STATE OF MAINE  
DEPARTMENT OF TRANSPORTATION  
16 STATE HOUSE STATION  
AUGUSTA, MAINE 04333-0016

October 3, 2023  
Subject: Penobscot Narrows Bridge  
and Observatory Lighting Improvement  
State WIN: 024595.00  
Location: **Verona & Prospect**  
**Amendment No. 1**

# E-03

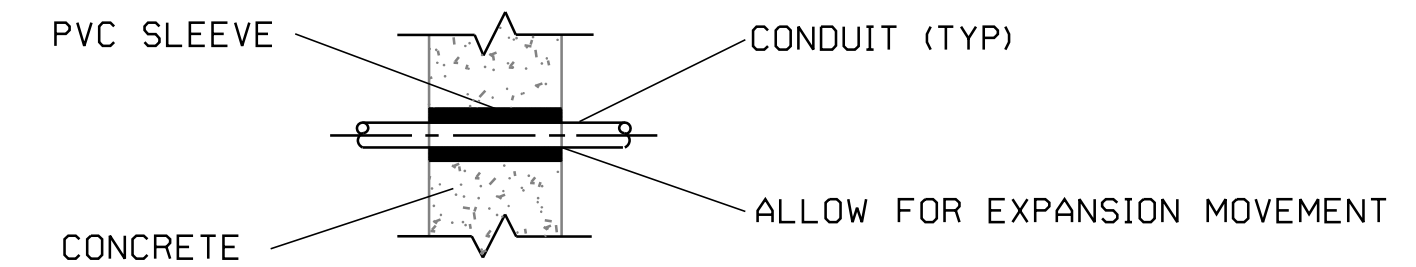
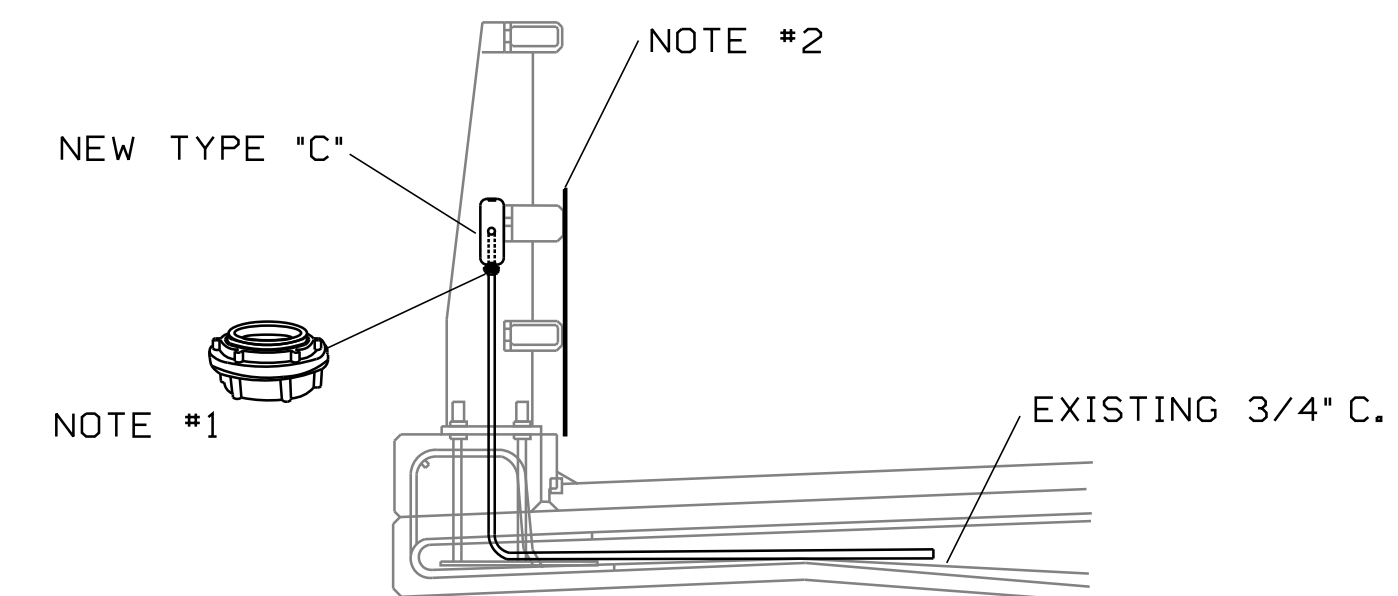
**Question:** Drawing No. E-03 indicates an existing pullbox for the cable stay lighting. What's existing is an "LB" type fitting which will only support the connection of one fixture. Is the intent to replace the "LB" with a "T" fitting, or more preferably a small PVC pullbox. Please advise.

**Response:** The drawings were noted as having an existing j-box, they are in fact LB fittings. The intent for the new design is to use new PVC 4" x 4" junction boxes to feed the (2) Stay Lights at each location. Please refer to updated plans and special provision.

E-10

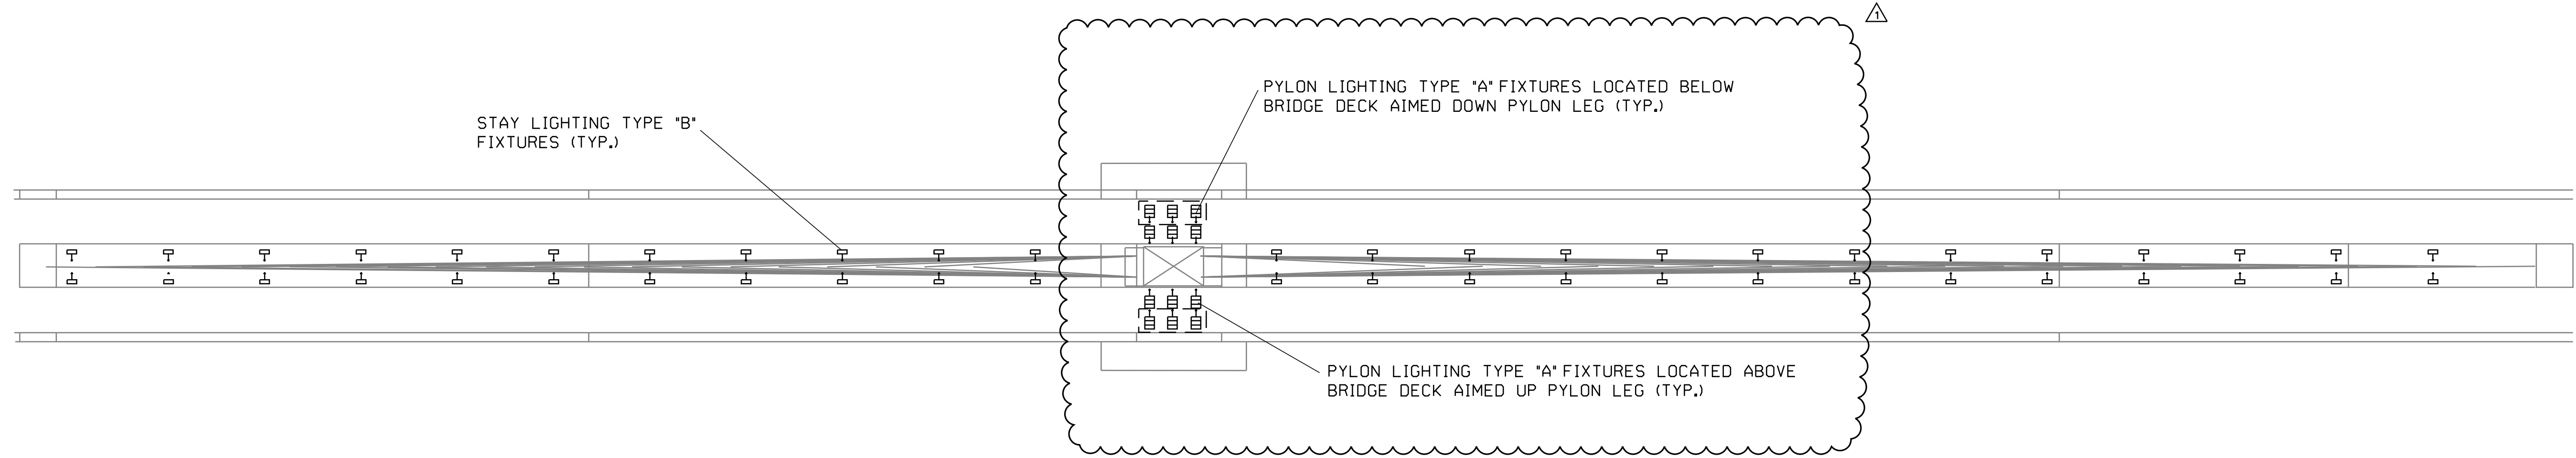
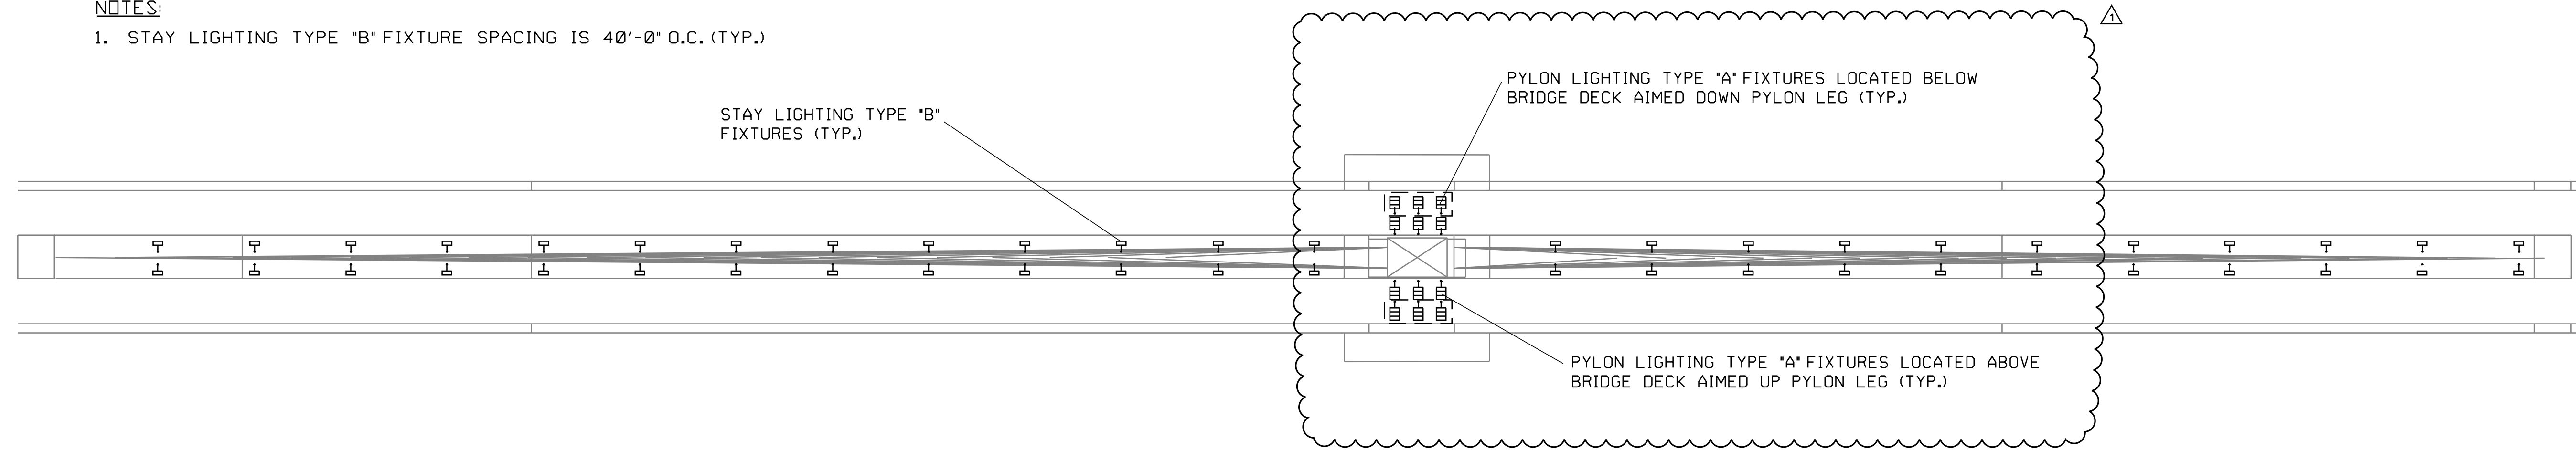
**Question:** The existing type light fixtures all use conduit bodies as junction boxes for their light whip wire feeds. The new type A and B LED fixtures call for junction boxes for their light whip wire feeds. The NEC recognizes conduit bodies as junction boxes. Are the existing conduit bodies acceptable junction boxes for the new LED light fixtures? If not, can MeDOT specify a junction box size and type for the type A and B fixtures? I believe the existing conduit bodies will work, unless the MeDOT requires dimming or color change options for the new LED fixtures.

**Response:** The new pylon lights are to be Type A and were incorrectly shown on the drawing as Type A for the upper pylon and Type B for the lower. The proposed lights are not equipped to be daisy chained from each other. If the existing "Tee" conduit body is in acceptable condition and the existing conduit is at least 3/4" then the conduit body would meet NEC Chapter 9 Table 1 requirements as noted in 314.28(3). The EC can then splice the specialized whips for each fixture to the next light at each fitting. In either case it is recommended that the existing rusting junction box on the interior faces of each pylon be replaced with new. Please refer to updated plans.
